Re: Santee Cooper Response to SCDHEC November 25 Request for Information regarding the draft NOMA for the Proposed Pee Dee Generating Station

Please find below Santee Cooper's responses to the questions that DHEC has raised regarding the comments that the Southern Environmental Law Center et al submitted on the Notice of MACT Approval (NOMA) for the proposed Pee Dee Generating Station. To further supplement the answers below, where appropriate, Santee Cooper also is attaching earlier submissions made to the record that are responsive to the particular issue or concern raised by SELC.

FIGURE 2-1. ESP REMOVAL EFFICIENCIES

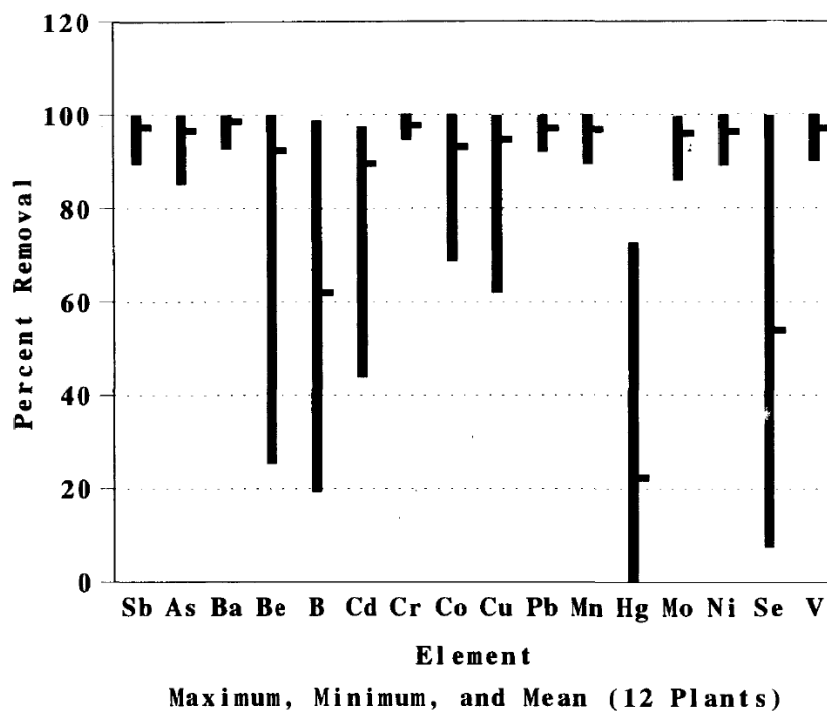
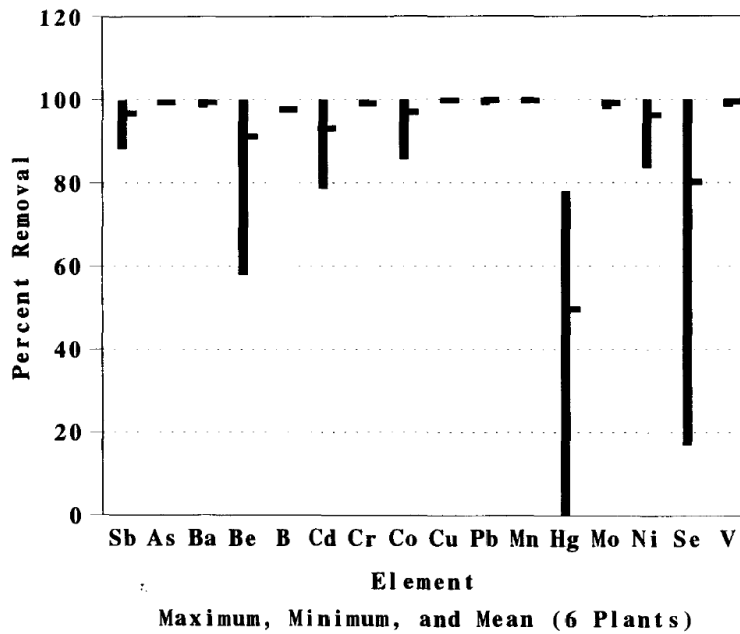
- (5) Provide information indicating each of the listed HAPs is invariably present in the surrogate stream to justify the use of that surrogate with the HAP. For example, on page 35 of SELC comments, it was discussed that selenium is emitted in the gas and may not be controlled by the fabric filter. On page 41 SELC comments on various classes of HAPs "that behave differently during combustion."

*With regard to selenium, the primary distinction between the current version of AP-42 and the passage quoted by SELC in their NOMA comments is the final parenthetical phrase: primarily mercury and, **in some cases**, selenium, which is relevant because SELC takes exception to the inclusion of selenium as a HAP adequately reflected in the choice of a PM-10 surrogate. The probable reason for EPA's ambivalence ("in some cases") regarding selenium can be found in two graphics, published in a DOE report cited by SELC on other issues, and provided below as Figures 2-1 and 2-2.⁷ Note that, for the power plants tested, an ESP*

was effective in capturing only about 55% of selenium emissions (Figure 2-1). However, the units with baghouses (fabric filters) were effective in capturing 80% of selenium emissions. One could speculate that the selenium emissions were adsorbed and captured with particulate matter in much the same manner that (primarily gaseous) mercury emissions are effectively captured by fabric filters (but not ESPs). Alternatively, the fabric filters may be better at capturing selenium because they are more effective at capturing fine particles, and fine particles may contain a significant portion of the selenium emissions. Figure 1.1-1 (From AP-42) and provided below demonstrates that, for 1-2 μ m diameter particles, a baghouse system has about one-half the emission rate of an ESP system. It is worth noting that the DOE report found that wet scrubbers (which are generally effective in capturing condensable gases) controlled about 30% of selenium from bituminous coal-fired power plants. The unavoidable conclusion from this data is that a fabric filter control system, such as proposed by Santee Cooper for the Pee Dee unit, is likely to capture the vast majority of selenium emissions as particulate matter, far more than will be captured by an ESP system, and at least twice as much as would be captured by a system targeting gaseous emissions (a wet scrubber). Hence, for the Pee Dee control configuration, PM-10 is an optimal surrogate for selenium. SELC also criticizes the use of PM-10 as a surrogate for arsenic, chromium, and nickel emissions (p.37). Note that Figure 2-2 from the DOE report shows that for the units tested by DOE, nearly 100% of the arsenic, chromium, and nickel in coal was captured by fabric filter systems. Hence, PM-10 is the optimal surrogate for these HAPs.
